RE: WDNR Comments on *90% Remedial Action Design Report – Upland Area*

The *90% Remedial Action Design Report - Upland Area (RAD)* was prepared by Foth Infrastructure & Environment LLC (Foth) and submitted to Wisconsin Department of Natural Resources (WDNR) on behalf of Superior Water, Light & Power, (SWL&P) on September 14, 2021. WDNR provided comments in a 90% *RAD* approval letter received via email on December 23, 2021.

SWL&P RESPONSE TO DNR COMMENTS ON THE 90% REMEDIAL ACTION DESIGN DELIVERABLES
SWL&P Former MGP Site, Superior, Wisconsin

SUPERIOR WATER, LIGHT & POWER		
FIGURE 2-6		
APPROXIMATE EXTENT OF COMBINED SOIL AND GROUNDWATER CONTAMINATION REMEDIAL ACTION OPTIONS REPORT, SEDIMENT AREA SUPERIOR, WISCONSIN		
Date: MARCH 2022	Revision Date:	
Drawn By: SGL	Checked By: BDS1	Project: 18S024

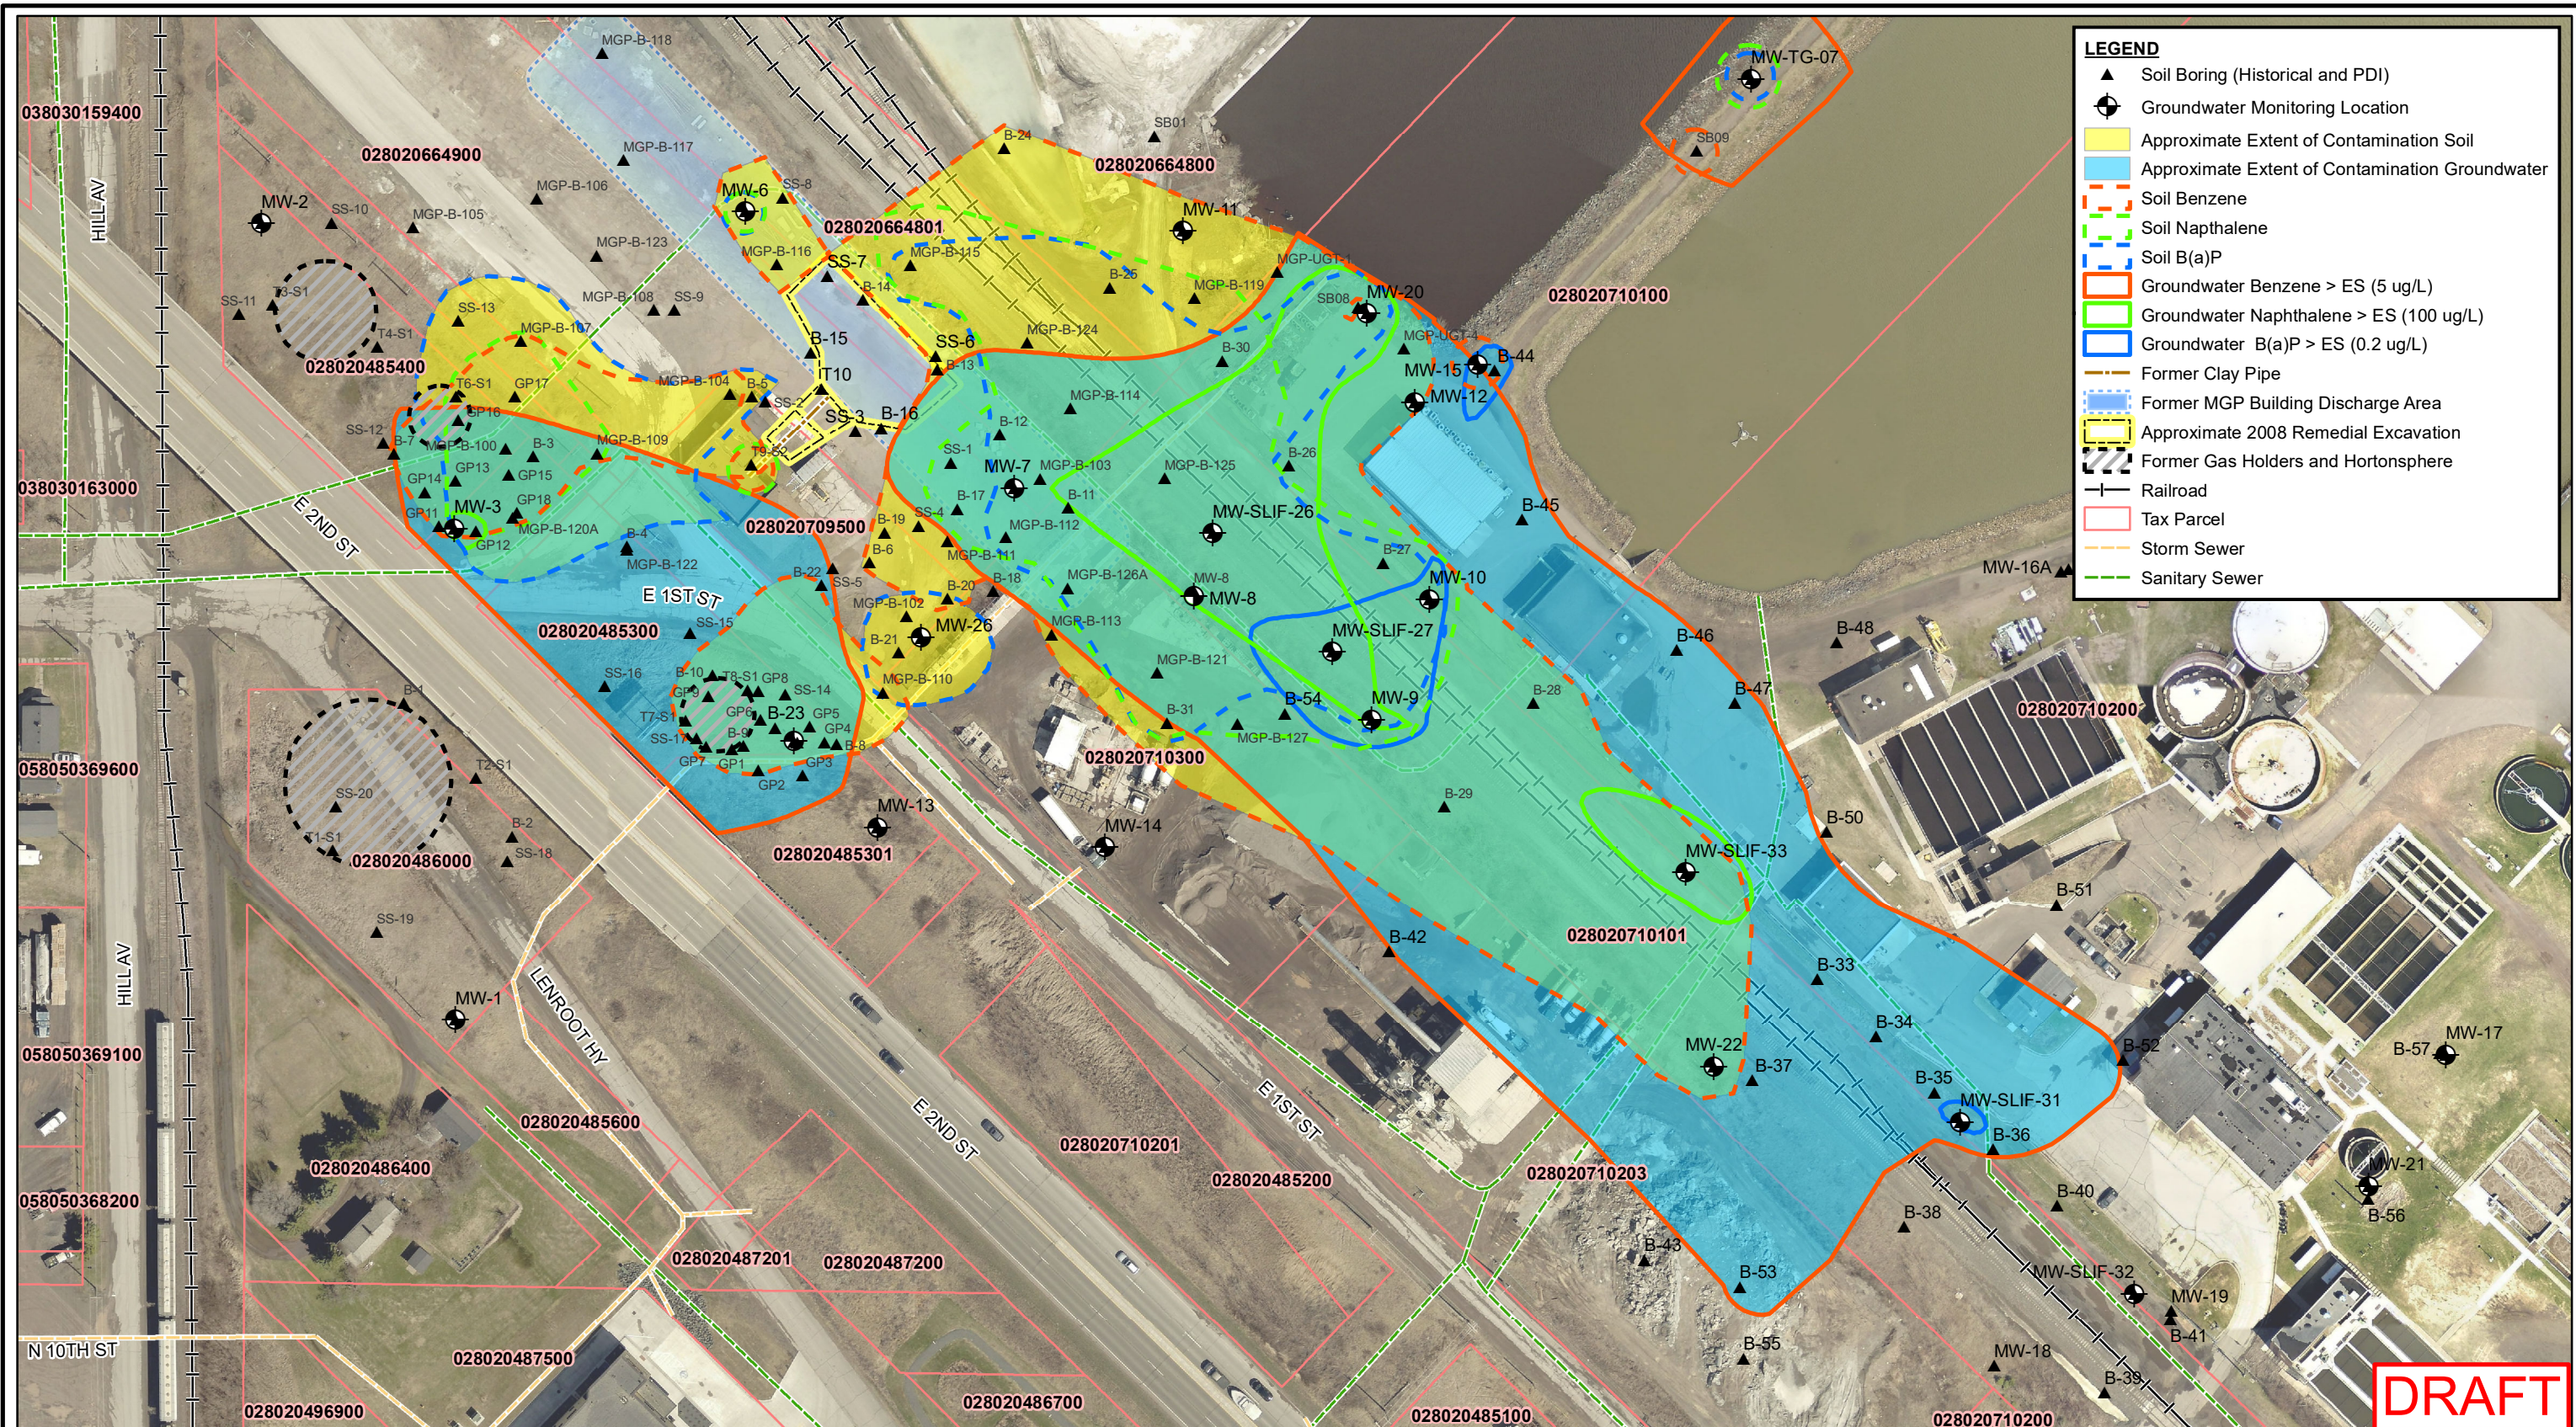
Comment No.	WDNR Comment per December 23, 2021 Letter	SWL&P Response
15	<p>Section 1.4, page 5, first paragraph, third sentence: The DNR <u>does not</u> agree that the contamination detected in the area of the City of Superior Wastewater Treatment Plants is “likely due to facility construction and fill activities unrelated to MGP operations”. This has not been shown to be the case through the SI activities conducted to date. The DNR <u>does</u> concur that the infrastructure in this area of the Site limits options for active remedial action. Further monitoring during and following active remedial action will be used to evaluate this area of the Site to determine what additional actions, if any, are warranted for compliance with Wis. Adm. Code chs. NR700-799 and Wis. Stats. ch. 292. Remove the phrase “likely due to facility construction and fill activities unrelated to MGP operations”.</p>	<p>The referenced phrase was not removed from the document. The available figures and data do not show connection of discontinuous and anomalous contaminants between the MGP site and the City's WWTP. The City constructed the WWTP about 1974 with fill. The source and quality of that fill has not been provided to SWL&P in any available documentation. Furthermore, there has been no documentation that no other chemical releases on City WWTP property have occurred that would account for the anomalous contaminants. (See revised Figure 1 - Limits of Soil and Groundwater Contamination)</p>
